April 2020
INT FL834
NHTSA #19V-722
Transport Canada #19-508
SECOND REVISED INTERIM RECALL

Subject: Western Star Baggage and Sleeper Doors

REVISION: Additional instructions have been added to steps 4 and 5 for making the trimmed notch less noticeable.

Fig. 1, Door Flange Trim Location

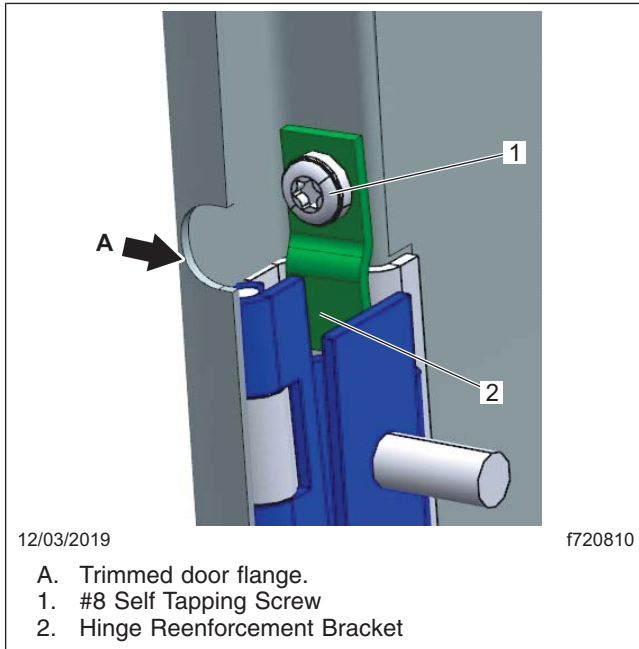
4. Mark out the areas of the door flange to be trimmed to allow tool access for a #8 self tapping screw. See **Fig. 1**, ref. **A**.
 - 4.1 Holding the bracket in place, mark the outer flange using the fastener hole in the bracket as a guide. This mark will be the centerline of the tool access notch.
5. Notch the door flange surface. See **Fig. 2**.
 - 5.1 Using a rotary tool, cut a 10mm circular notch in the flange, extending the notch halfway down the flange.

NOTE: the farther the notch is extended into the flange the more noticeable it will be once the door is reinstalled onto the vehicle.

- 5.2 Check for fastener installation clearance. If needed, extend the notch further.

Fig. 3, Door Hinge Trim Location

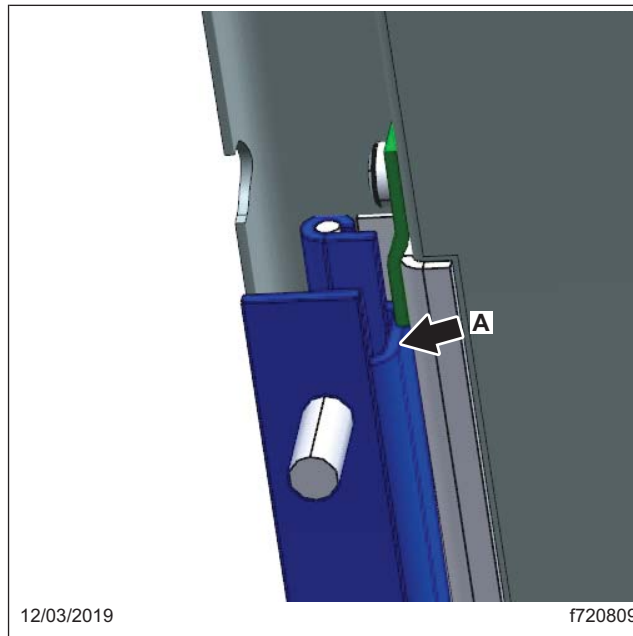
6. Mark out the areas of the door hinge that will need to be trimmed to allow clearance for the new bracket. See **Fig. 3**, ref. **A**.
7. Trim the door hinge as shown in **Fig. 3**. Trimming past the bend in the hinge to allow full range of motion.

Fig. 4, Hinge Reinforcement Assembly

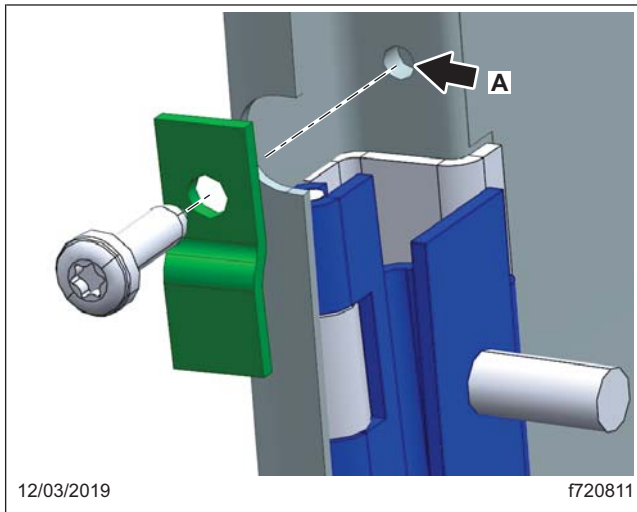
8. Install the new brackets to the top and bottom of the hinge using #8 self tapping screws and tighten the screws to 10 lb-in (113 N·cm) and not to exceed 2500 rpm. See [Fig. 4](#) and [Fig. 5](#)
